10/549,501

Luc Uytterhaeghe

Office Action Summary	Application No. 10/549,501	Applicant(s) UYTTERHAEGHE ET AL.	
	Examiner ELIZABETH VOLZ	Art Unit 3781

DETAILED ACTION

Figure 2 (Uematsu)

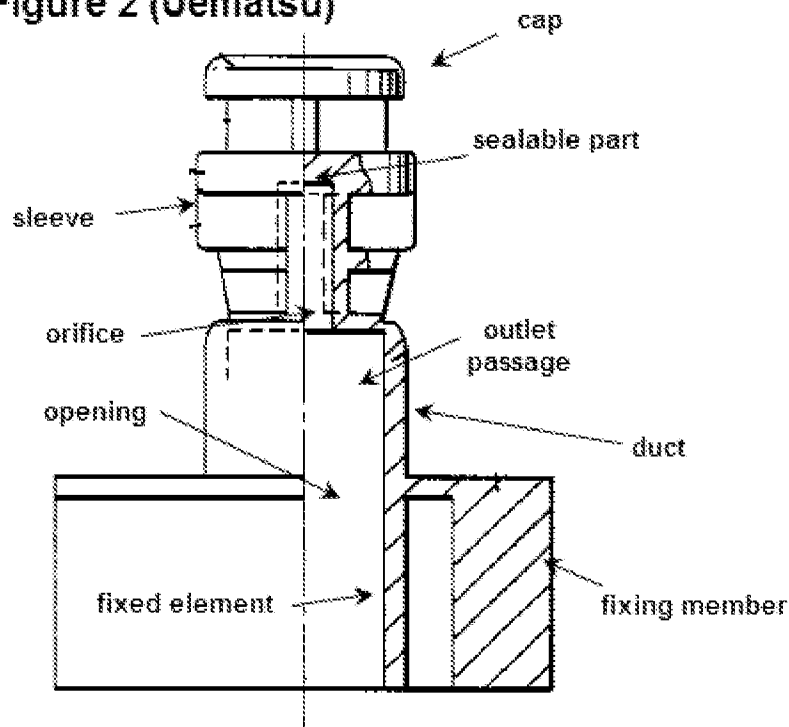
4. Regarding Claim 1, Uematsu discloses a closure device 20 (Figure 2) intended to be mounted on an opening (Figure 2 below) of a fluid product reservoir, said device being formed as a single piece by injection molding (Column 1, Line 56) plastic material (Column 4, Line 12) and comprising a fixing member (Figure 2 below) intended to cooperate with the reservoir opening to form a sealed attachment, a dispensing duct (Figure 2 below) forming an outlet passage (Figure 2 below) for the fluid product contained in the reservoir, said duct forming a dispensing orifice (Figure 2 below), a closing member 20 (Figure 2) to close and seal said duct, said closing member being joined to the dispensing duct by at least one bridge of material 28 (Figure 10A) intended to be broken when the closing member is first removed, characterized in that said closing member comprises a sealable part (Figure 2 below); said sealable part, before sealing, leaving the dispensing orifice clear and, after sealing, closing the dispensing orifice in sealed manner.

5. Regarding Claim 2, Uematsu discloses a closing member 20 (Figure 2), dispensing duct (Figure 2 above), and at least one bridge of material 28 (Figure 10A) are formed as a single piece (Figure 2).
6. Regarding Claim 3, Uematsu discloses a sealable part (Figure 2 above) which is deformable and can be welded to itself (Figure 2).
7. Regarding Claim 4, Uematsu discloses a sealable part (Figure 2 above) which comprises a fixed element (Figure 2 above), connected to the duct by at least one bridge of material 28 (Figure 10A), and a sealing cap (Figure 2 above) intended to be fixed irremovably on the fixed element, said cap closing and sealing the dispensing orifice.

8. Regarding Claim 5, Uematsu discloses a cap (Figure 2 above) which is connected, articulated fashion, to the fixed element (Figure 2).
9. Regarding Claim 6, Uematsu discloses a cap (Figure 2 above) and a fixed element (Figure 2 above) which are formed as a single piece.

10. Regarding Claim 7, Uematsu discloses a cap (Figure 2 above) which is welded onto the fixed element (Figure 2).
11. Regarding Claim 8, Uematsu discloses a cap (Figure 2 above) which forms a sealing bush (Figure 2 above) intended to come into sealed contact with the duct for its sealed closing.

13. Regarding Claim 10, Uematsu discloses a closing member 20 (Figure 2) which comprises a peripheral sleeve (Figure 2 above) connected at one end to the outside of the duct by said at least one bridge of material 28 (Figure 10A), said sleeve comprising as opposite peripheral end forming the sealable part.

14. Regarding Claim 11, Uematsu discloses a duct (Figure 2 above) and a closing member 20 (Figure 2) which are provided with snap-fit means 29 (Figure 10A) intended to cooperate after the breaking of said at least one bridge of material.
